FARIHA KNIT TEX LTD.

(Extension Buildings)

Baroibogh, Enayet Nagar, Fatullah, Narayanganj.
(23.619862N, 90.482921E)
8th & 30th November 2021

Observations

Undocumented horizontal expansion

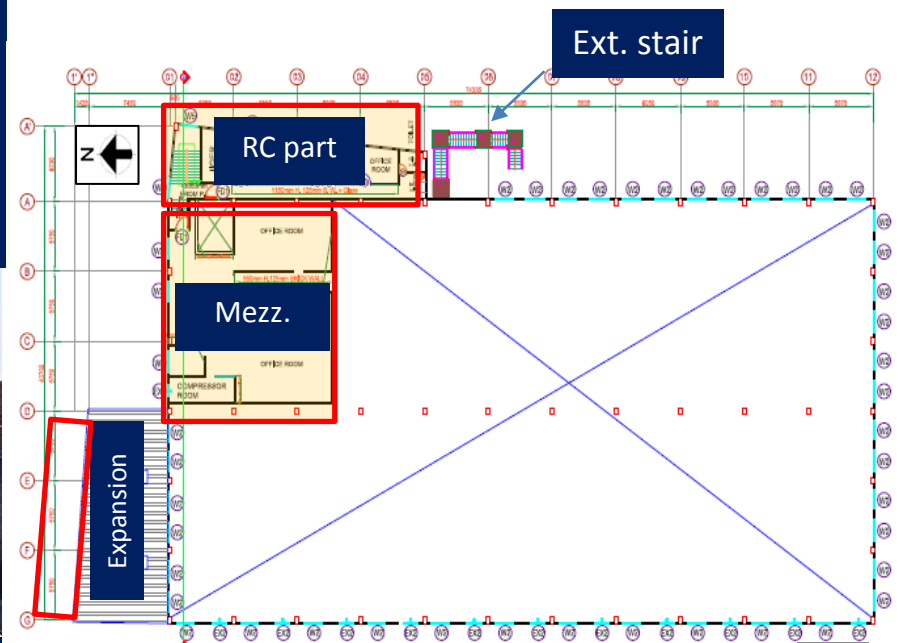
Undocumented horizontal expansion was observed on north side of the shed. Building engineer is required to survey the structure and prepare as-built drawings and check the adequacy of the structural members for the vertical & lateral forces.

Deflection of roof top RC slab

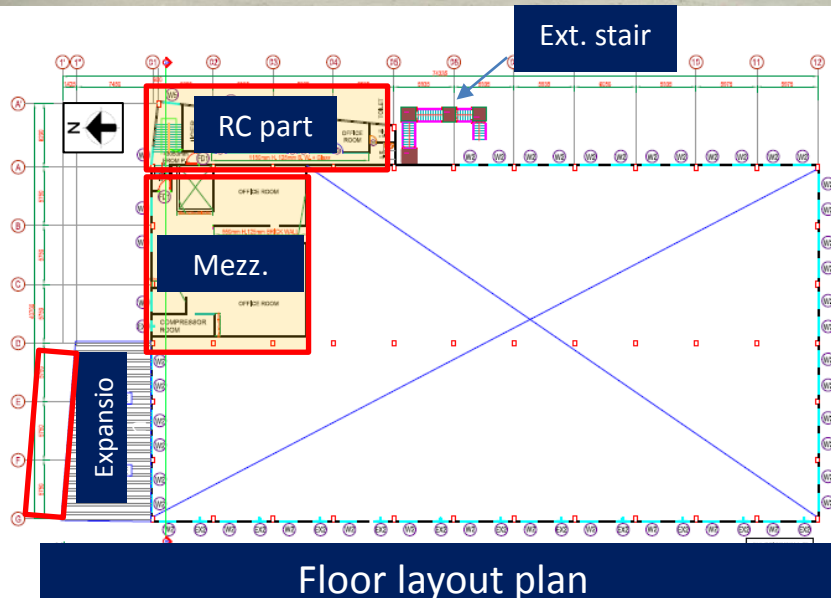
The stair roof slab have about 5m span and 125 mm thickness. Deflection was observed at the mid span of the slab. Also, hairline crack on the slab soffit was observed. The slab have no periphery beams. The building engineer to check the adequacy of the slab and suggest necessary support to control the deflection.

Lack of design report

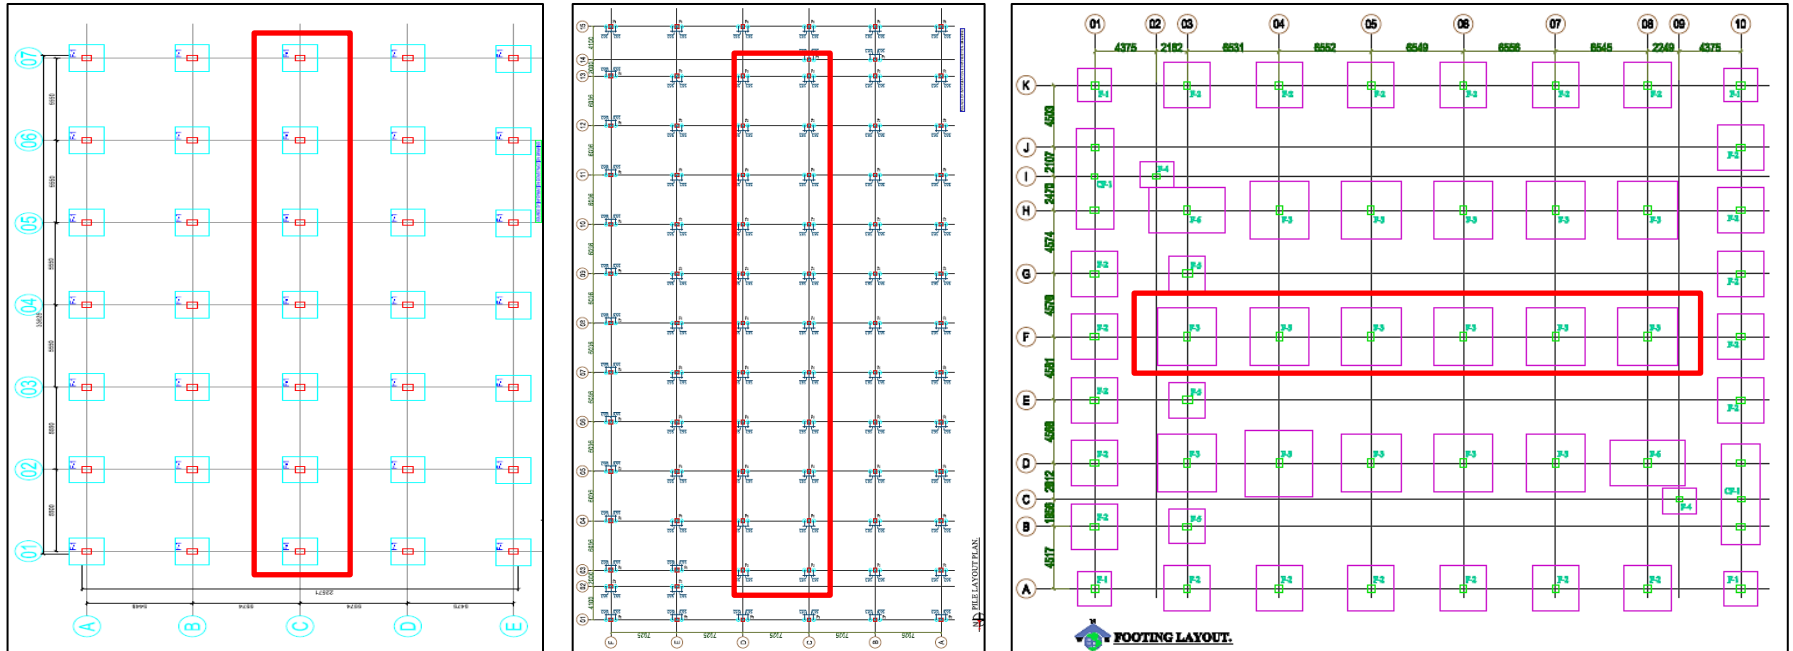
As per BNBC, every building or structure designed shall have its design documents prepared in accordance with the provision of Section 1.9.1. The design document shall include a design report, and a set of structural drawings, which shall be prepared in compliance with section 1.9.1.1 and section 1.9.1.2 as per BNBC. At the time of inspection, no design report was available which is required to be prepared in compliance with section 1.9.1.1 (part-6, BNBC).

Main shed, RC part and steel mezzanine floor are sharing common RC columns. Also, the expansion areas are structurally connected with main shed. Some RC columns, almost all the steel columns and rafters have been retrofitted by the factory. Mezzanine floor steel column has no foundation details. All the parts should be included in the analysis and design report.

Lack of lateral stability

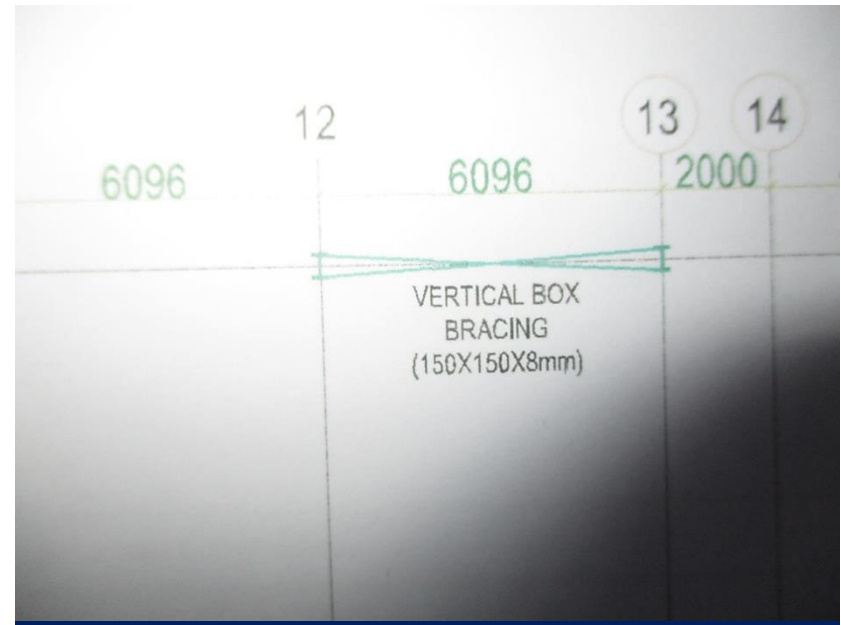
Absence of lateral load transfer media (compression strut) on roof

The building engineer is required to check the stability of the structural system and provide the appropriate load transfer media.
